US 97 BAKER RD INTERCHANGE AREA MANAGEMENT PLAN (IAMP)

BEND MPO POLICY BOARD MEETING
FEBRUARY 15, 2022

Alt. 1: Enhanced Existing Ramp Terminals

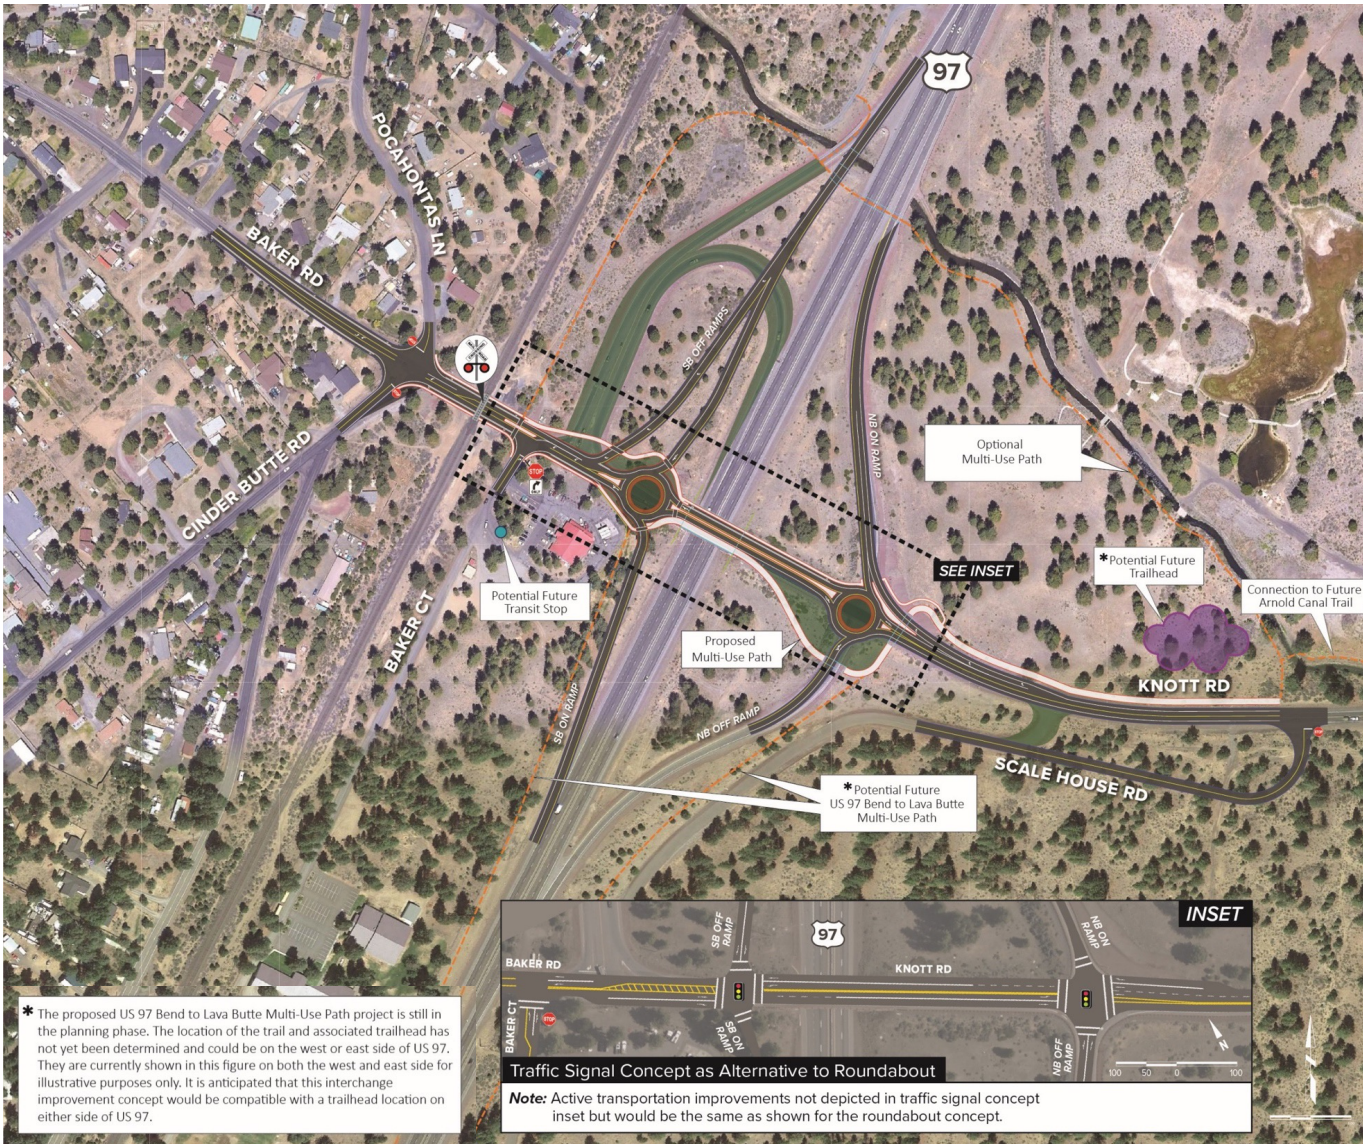
- Alternative 1 brings the ramp terminal close to the railroad but also resolves access conflicts
- Alternative 2 has a less desirable at-grade crossing with the multi-use path on the south side
- Alternative 2 does not fully address access conflicts on the west side
- Alternative 3 cost is high, and the complex construction risks may increase the cost further
- Alternative 3 may be more difficult to build in phases
